## Docket No. 272 - Development and Management Plan Inspection

## **Segment 4a Underground Line**

Date: October 4, 2006

Location: Singer Substation to Fairfield/Westport Town Line

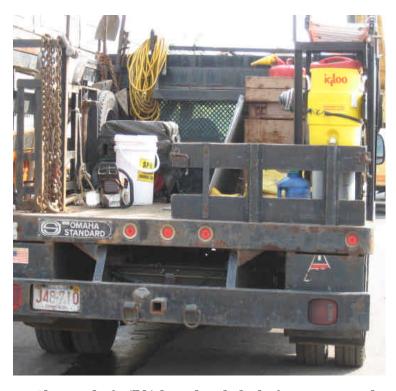
$\label{thm:continuous} Trenching \ activities \ at the intersection \ of \ Atlantic \ Ave. \ and \ Broad \ St. \ Please \ note \ protected \ catch \ basin.$
